PRELIMINARY PLAT:

SUMMIT VIEW TOWNHOMES

#100212,1001294

March 1, 2023

Proposed Preliminary Plat

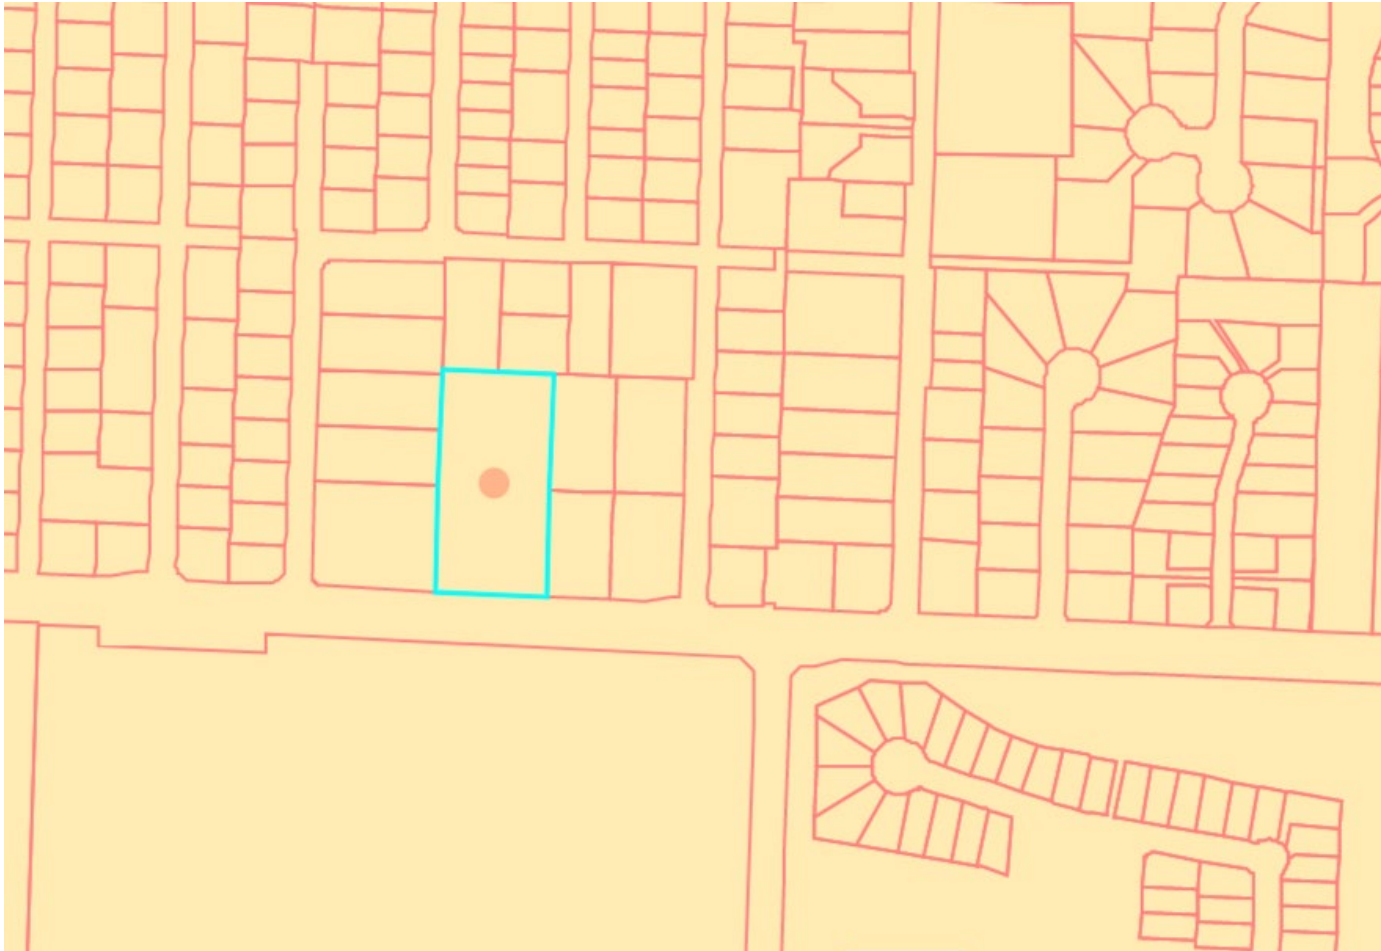
Staff Comment: The density requirement of the NCOR zone is measured per net developable acre (du/ac) and requires a minimum density of 6 du/ac and a maximum of 25 du/ac. The proposed density at 19.2 dwelling units is within the required range. There is no lot minimum lot size, or minimum width in the NCOR zone

Staff Comment: The applicant is meeting the off-street parking by placing the parking areas behind the proposed homes. Pedestrian connectivity has been made but shall not be painted. A change will be required to adhere to the code. Bicycle facilities are not required. Any transit stop requested will need to be approved by the traffic section of Planning and Public Works (PPW).

Staff Comment: The applicant will need to address lighting of the pedestrian ways along with drive aisles.

Proposed Landscape Plan

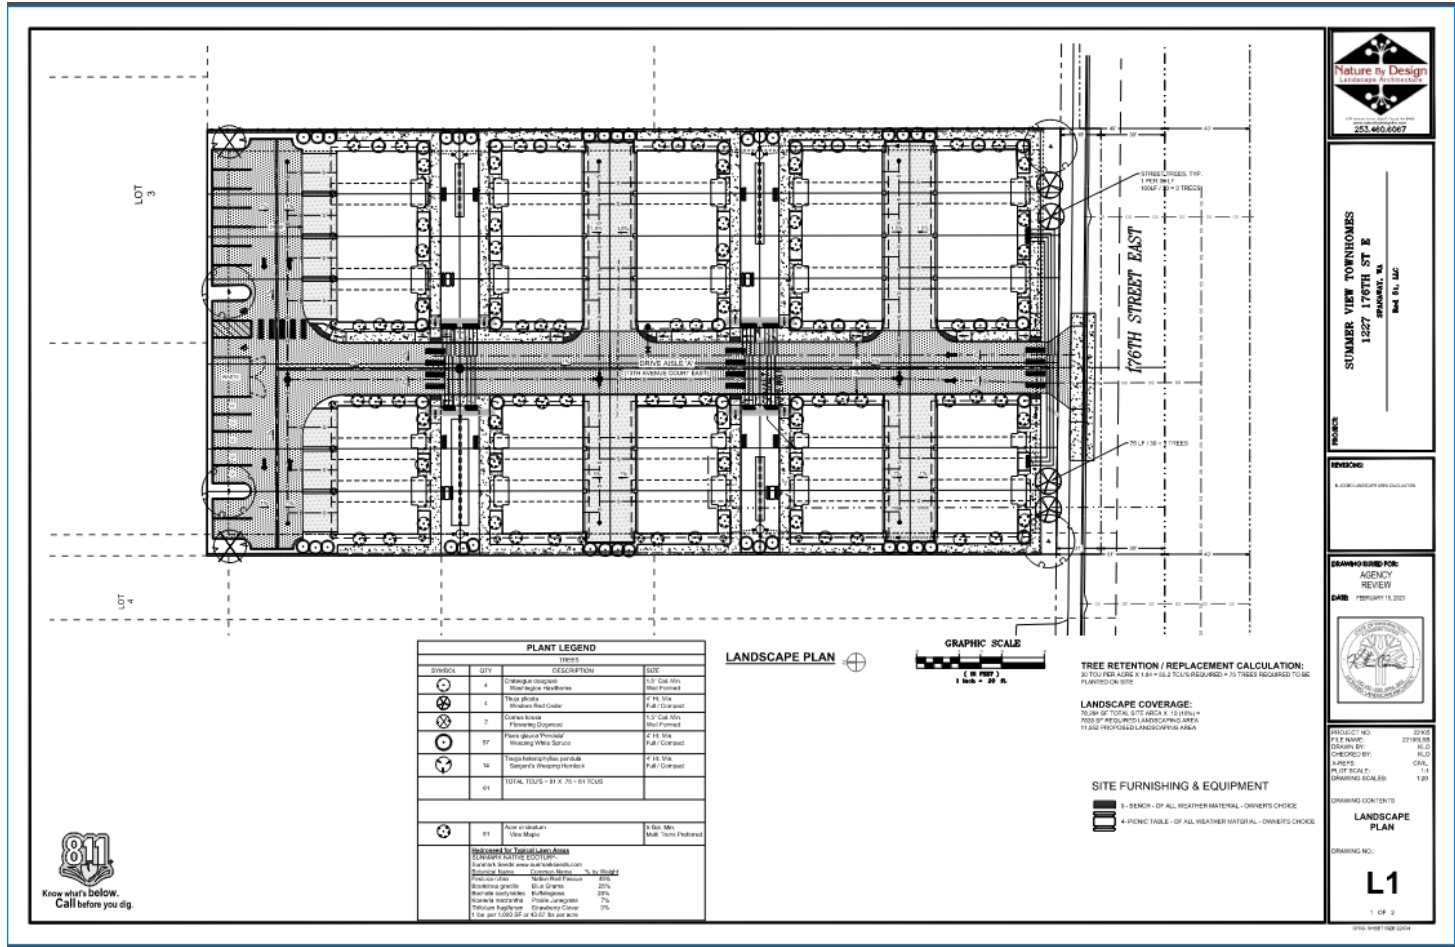
Staff Comment: The tree conservation code requires that 55 tree units be met for the 1.84-acre site (30 trees per acre x 1.84 acres). The applicant has proposed 81 tree units on the landscape plan. This requirement has been met.

Staff Comment: This requirement has been met with the landscape plan, dated February 15, 2023.

Staff Comment: Street trees are required along all new roads and accessways at a rate of 1 per 30 lineal feet of roadway, exclusive of intersections. Street trees are also required along 176th Street East. This requirement has been met.
